# Technical Memo

Project: I-29 Exit 77 (41<sup>st</sup> Street) Interchange and Environmental Study  
Project # PL0100(84) 3616P, PCN 05MH; IM0293(A6)77 3014N, PCN 03RA

Subject: Public Involvement Summary – April and May 2017

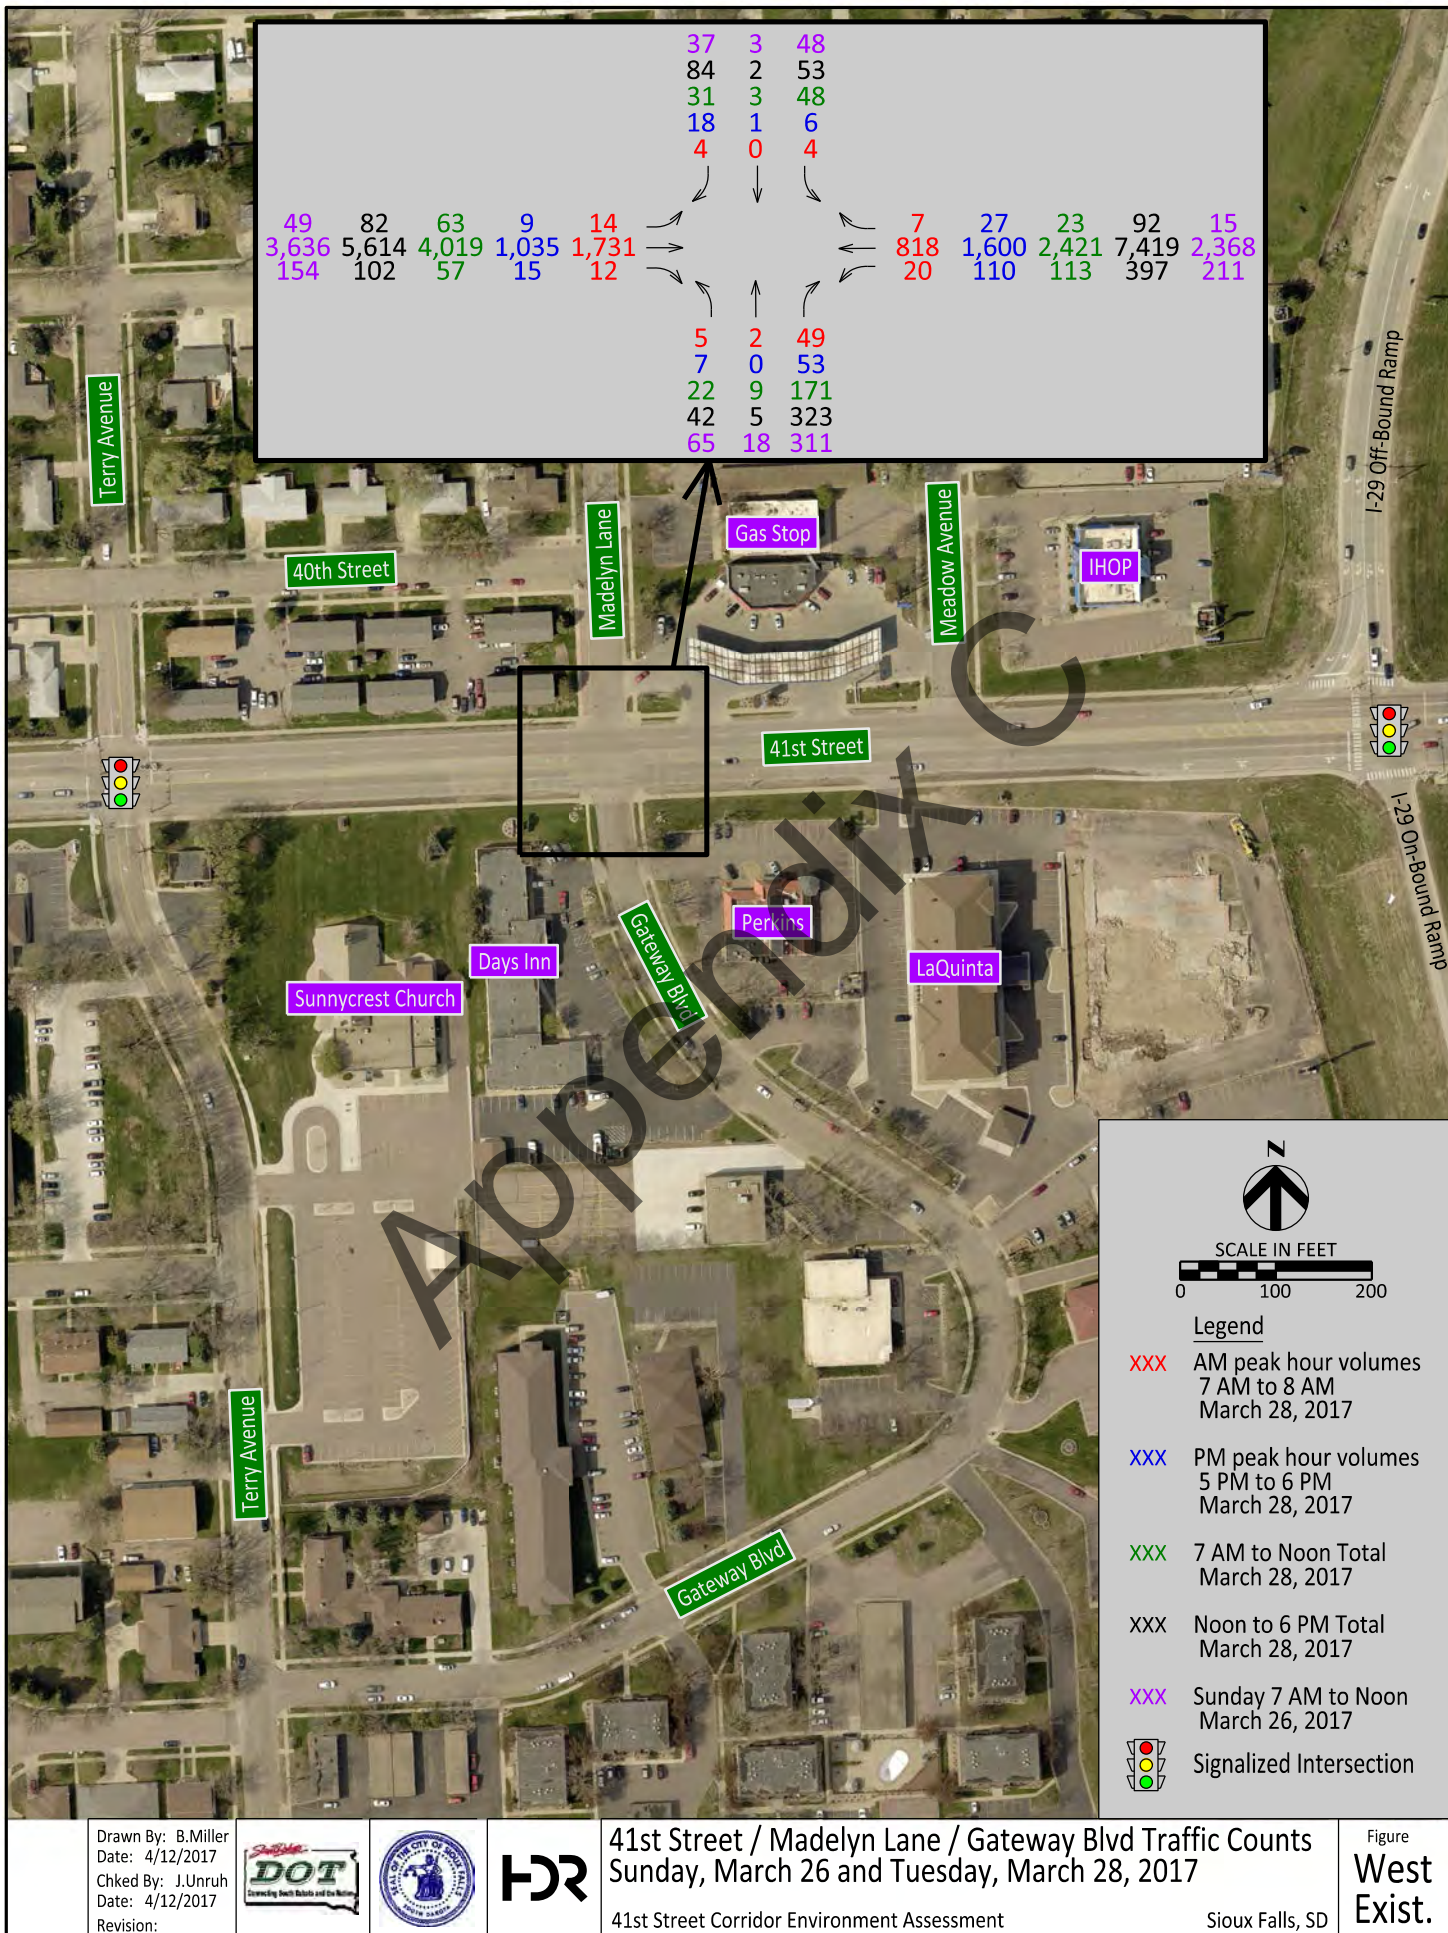
#### **4. Traffic counts at 41<sup>st</sup> Street/Madelyn Lane/Gateway Boulevard intersection (see Attachment 1)**

- 4.1 Traffic counts from March 2017 were reviewed, especially in the context of Alternative B1 which provides a 3/4 access raised median configuration at the 41<sup>st</sup> Street/Gateway Boulevard intersection.

- 4.2 It was noted there is now a relatively large percentage of traffic (83% to 91%) that turns right from Gateway Boulevard to eastbound 41<sup>st</sup> Street during all traffic count periods in comparison to traffic turning left to westbound 41<sup>st</sup> Street. This is shown in Figure West B1&B2 in Attachment 2. This indicates that much of the westbound traffic diverts to the signalized 41<sup>st</sup> Street/Terry Avenue intersection to make the left-turn movement.

Figure  
West  
B2

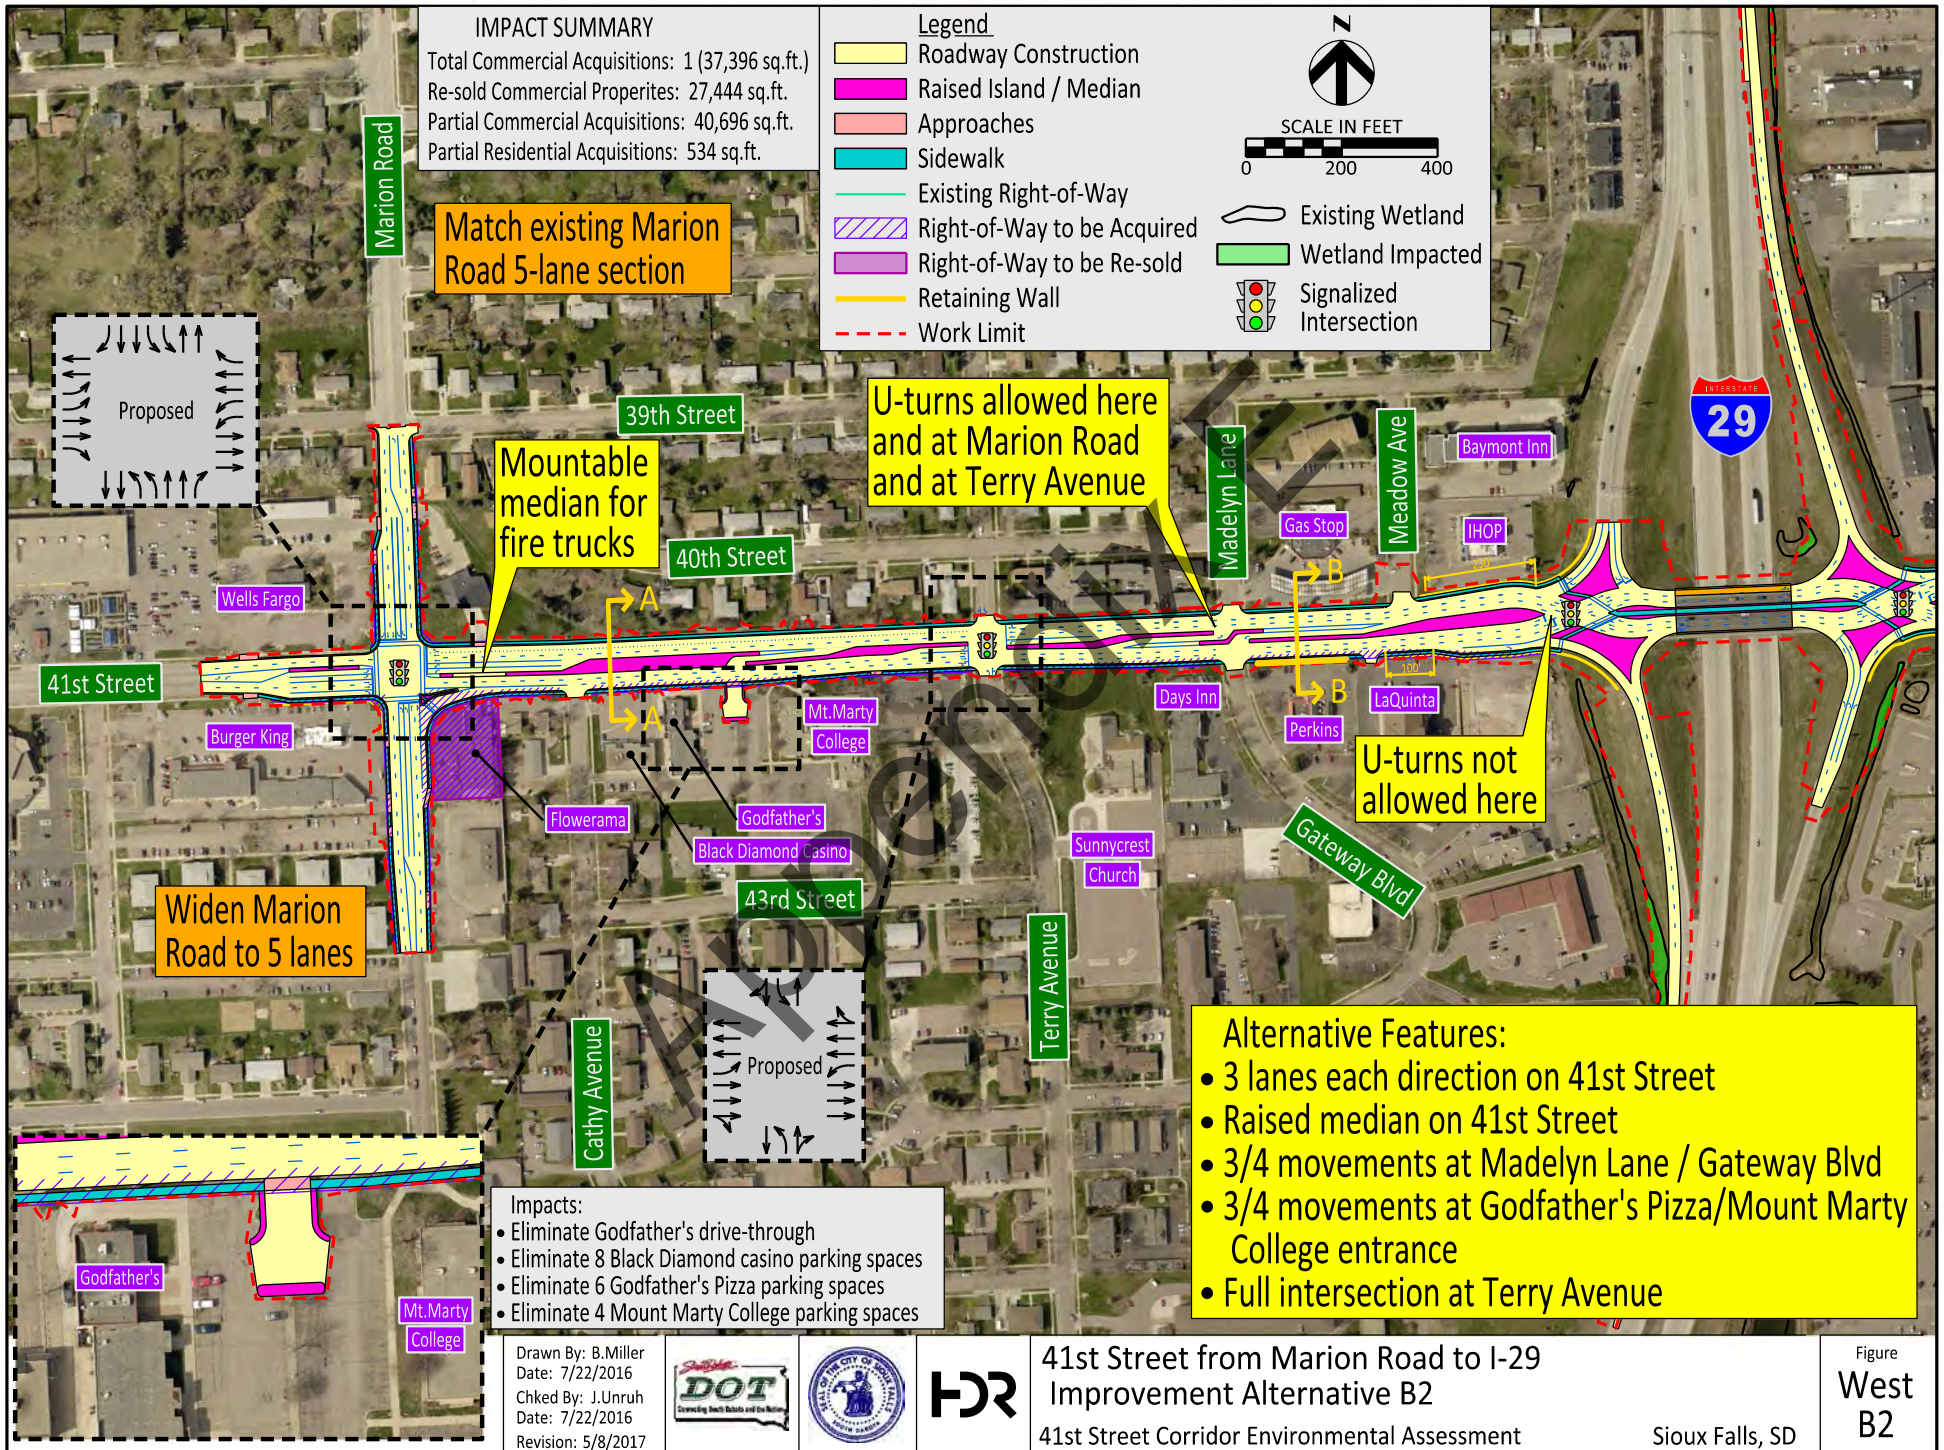
- 3.3 Alternative B2 was developed at the request of Mount Marty College at the 9/28/16 landowner meeting. The 3/4 access configuration between Marion Road and Terry Avenue is intended to provide improved access from westbound 41<sup>st</sup> Street to a joint Godfather's Pizza/Mount Marty College driveway.

- 3.5 As follow-up to the 4/24/17 meeting, Heine requested a more in-depth analysis of the impacts. Therefore, HDR had developed several graphics that provided more detail on the Alternative B2 impacts.

- 5.1 HDR will continue to recommend that Alternative B2 be eliminated from consideration for 41<sup>st</sup> Street improvements.
- 5.2 HDR will continue to recommend that Alternative B1 be carried forward into the final design and right-of-way acquisition phase of the project.
- 5.3 Final design and right-of-way acquisition will begin in 2018 or 2019.
- 5.4 41<sup>st</sup> Street improvements are scheduled to begin in 2023.

**Alternative 4**  
 West side Carolyn Ave cul-de-sac / Acquire Pizza Hut property  
 41st Street Corridor Environmental Assessment  
 Sioux Falls, SD

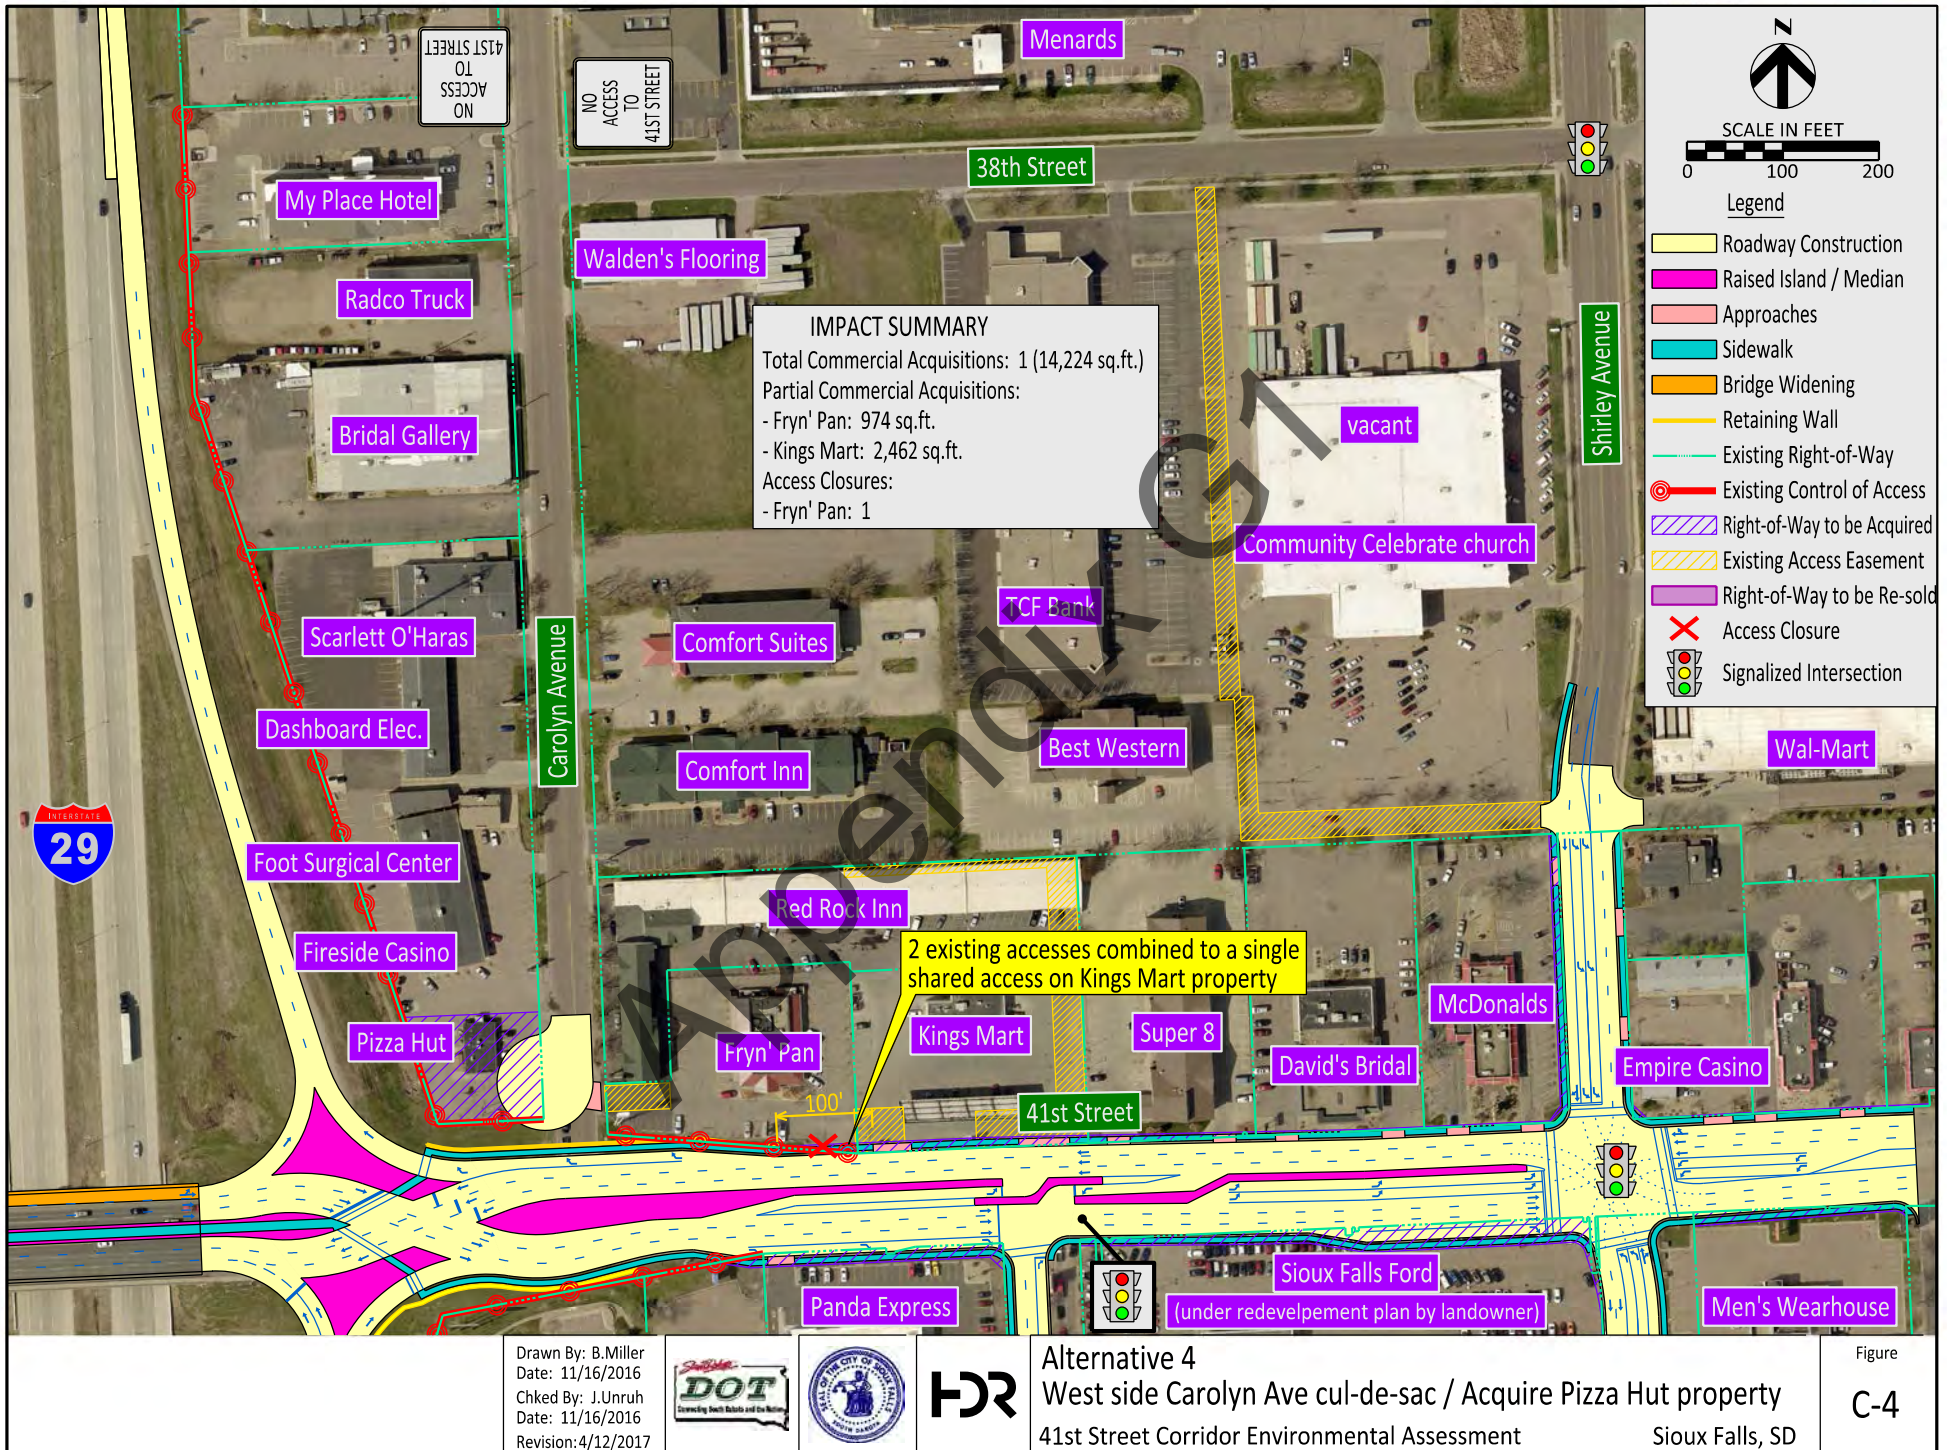
- 2.3 Fryn' Pan Restaurant
  - Recommended cul-de-sac Alternatives 4 and 5 would likely result in cut-through traffic from 41<sup>st</sup> Street to Carolyn Avenue within their property. The only way to eliminate cut-through traffic would be to close off the driveway to Carolyn Avenue. However, that would stop drivers from getting to eastbound 41<sup>st</sup> Street via Carolyn Avenue/38<sup>th</sup> Street/Shirley Avenue.

- Fryn' Pan's west driveway was added several years after they moved to the current site. Removal of that driveway as proposed with recommended Alternatives 4 and 5 is not desirable but may be necessary.

Comments from April/May 2017 I-29 Exit 77 (41 <sup>st</sup> Street) Public Involvement and Applicable Responses				
Property	Representative	Meeting	Concern(s)	Response(s)
Fryn' Pan Restaurant (4204 W. 41 <sup>st</sup> Street)	Dave Stukel	email dated 5/4/17 following 4/25/17 landowner meeting	<p>I think that it is important that I voice my opinion on the two alternatives that are still under consideration.</p> <ol style="list-style-type: none"> <li>1. EVERYTHING about Alternative 4 is going to have a negative impact on Fryn' Pan's business. This alternative will drastically impact the profitability of this restaurant. The median is a negative, the "combined driveways" are a negative, the "long route" to go home to the east is a negative, the increase in "cut through traffic" is a negative (to my parking lot's life span AND the safety of my customers). The combination of all these negatives is enough to drive a long-standing business "Out Of Business".</li> <li>2. All of these negatives still exist in Alternative 5, but at least in Alternative 5 Fryn' Pan could possibly be in a position to expand it's parking lot. This parking lot expansion could offset some or all of the negatives that would be piled upon my business.</li> <li>3. In visiting with my neighbor, King's Mart, they too have expressed that Alternative 5 is the least disruptive for Fryn' Pan and King's Mart.</li> </ol> <p>I would look forward to voicing my opinions at the public meeting on May 10 but unfortunately we will not be unable to attend. I trust that my opinion will be heard.</p> <p>Lastly I would like to sincerely thank you for the hard work that you consistently put into these projects.</p>	<ol style="list-style-type: none"> <li>1 The concerns raised appear to contradict support for Carolyn Avenue Alternatives 4 and 5 shared at the 4/24/17 landowner meeting. <ul style="list-style-type: none"> <li>• The proposed 3/4 access raised median configuration on 41<sup>st</sup> Street does not restrict any access movements <u>to</u> the Fryn' Pan.</li> <li>• The single combined driveway with King's Mart was the condition when the Fryn' Pan was established at this location in the 1970s. The driveway directly to the Fryn' Pan was installed several years later within the legal control-of-access for the I-29 interchange.</li> <li>• Patrons leaving the Fryn' Pan heading eastbound on 41<sup>st</sup> Street will need to utilize Carolyn Avenue, 38<sup>th</sup> Street, and Shirley Avenue. Although this is a longer route than turning left from Fryn' Pan directly to eastbound 41<sup>st</sup> Street, making left turns onto 41<sup>st</sup> Street is very difficult and unsafe at virtually any time of the day because of the high traffic volumes on 41<sup>st</sup> Street. The "long route" represents a beneficial safety aspect of Alternatives 4 and 5.</li> <li>• Cut through traffic may be a concern; however, the proposed improvements on 41<sup>st</sup> Street and at the Shirley Avenue/41<sup>st</sup> Street intersection will likely make the "cut-through" route less desirable for drivers than utilizing the street network.</li> </ul> </li> <li>2 There is no guarantee that Fryn' Pan would purchase any part of the Red Rock Inn property acquired with Alternative 5.</li> <li>3 Verbal comments from King's Mart representatives at the 4/25/17 landowner meeting indicated concurrence with Alternatives 4 or 5.</li> </ol> <p>The large cost differential between acquisition of the Pizza Hut property (Alternative 4) and the Red Rock Inn property (Alternative 5) leads us to move forward with Alternative 4.</p>
